CITY OF RIVERSIDE, CALIFORNIA
DEPARTMENT OF PUBLIC WORKS

IOWA AT BLAINE

700' S. IOWA TO 250' W. BLAINE

PROJECT NO. 225

R-1516

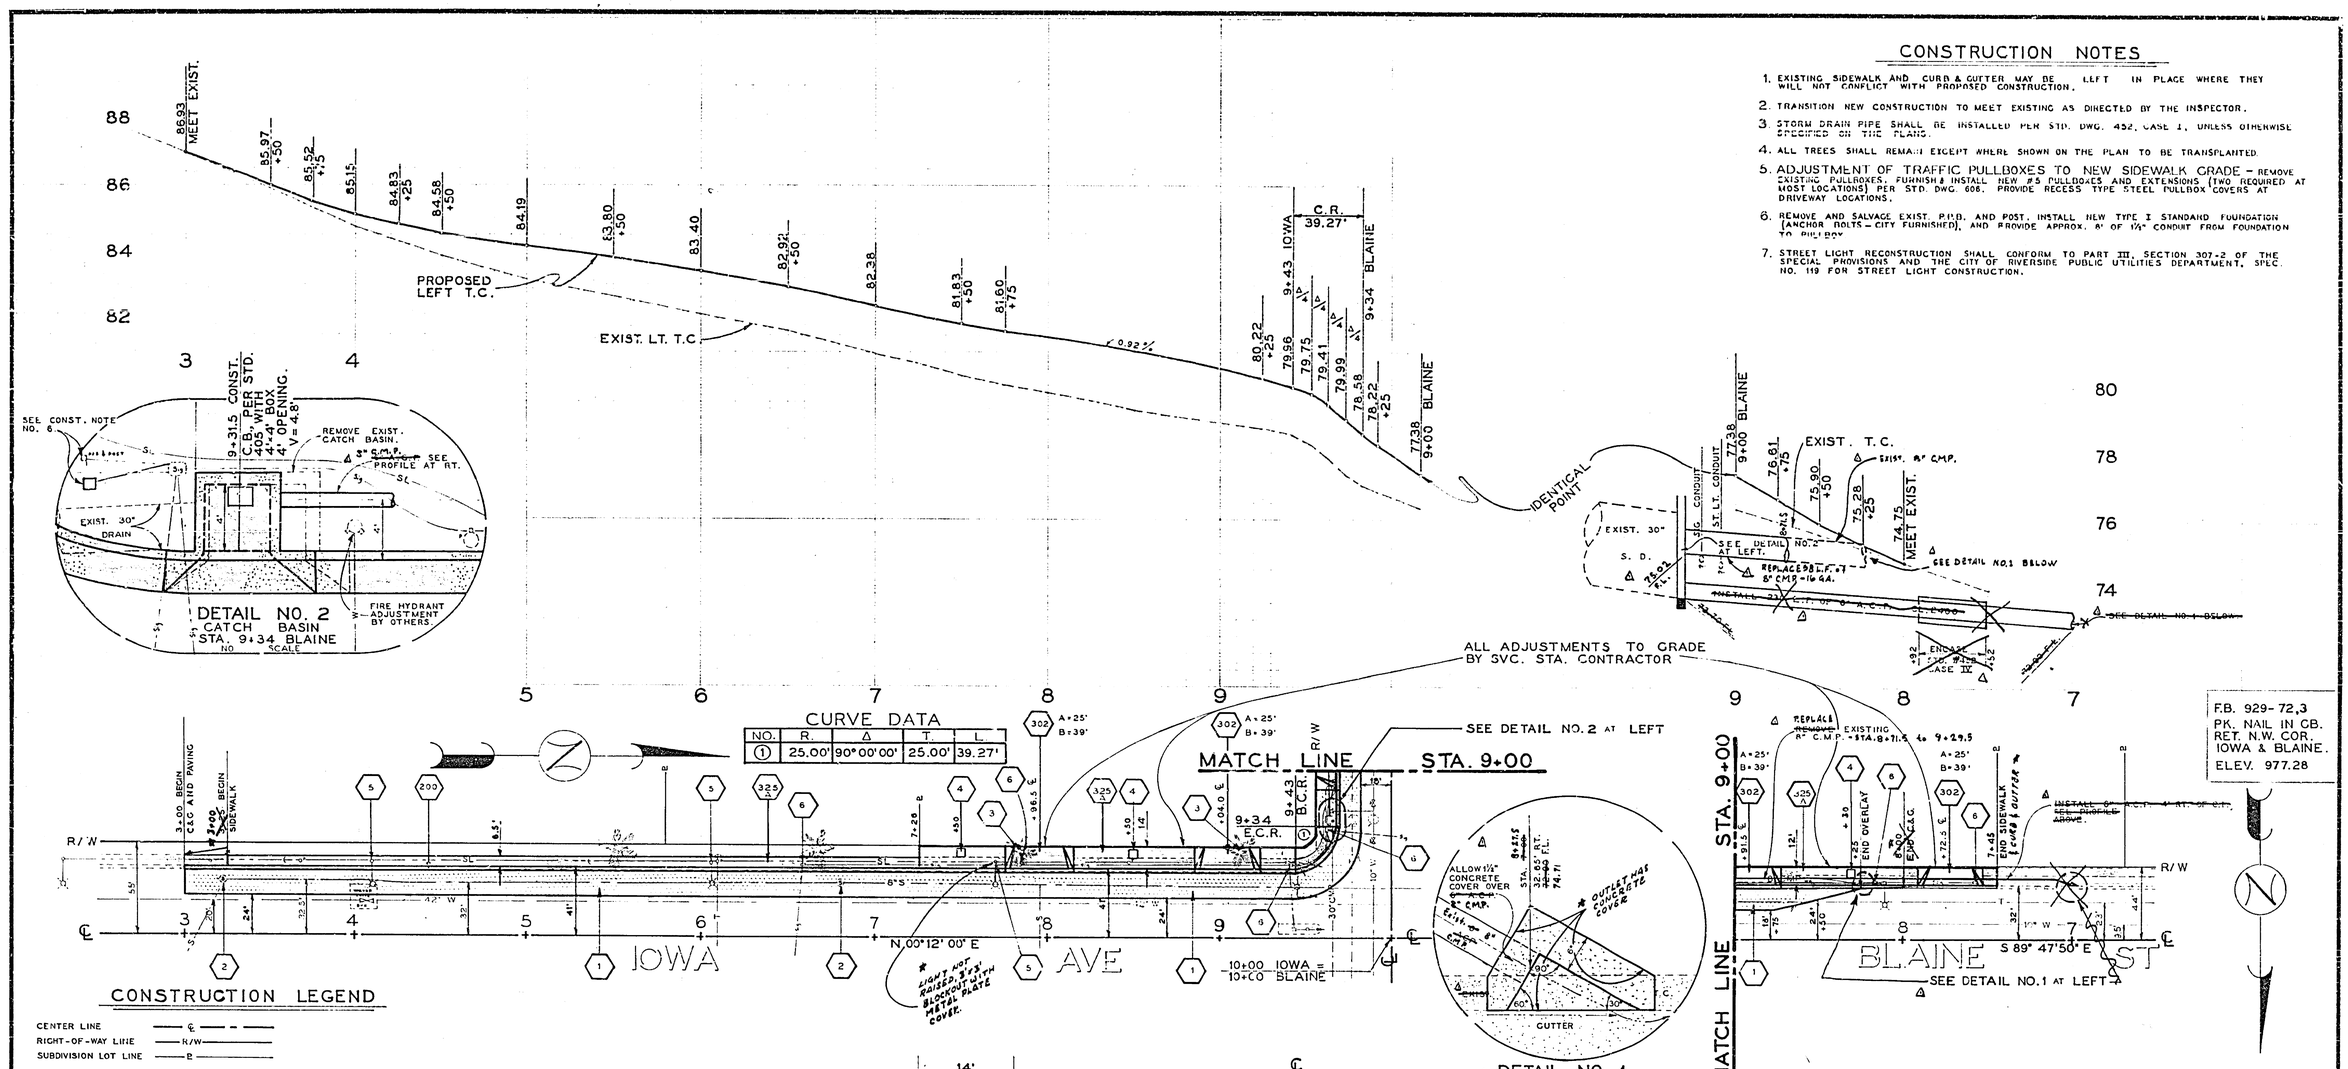
Δ Deleted 6" A.C.P., added 69' of 8" C.M.P. Per Addendum No. I.
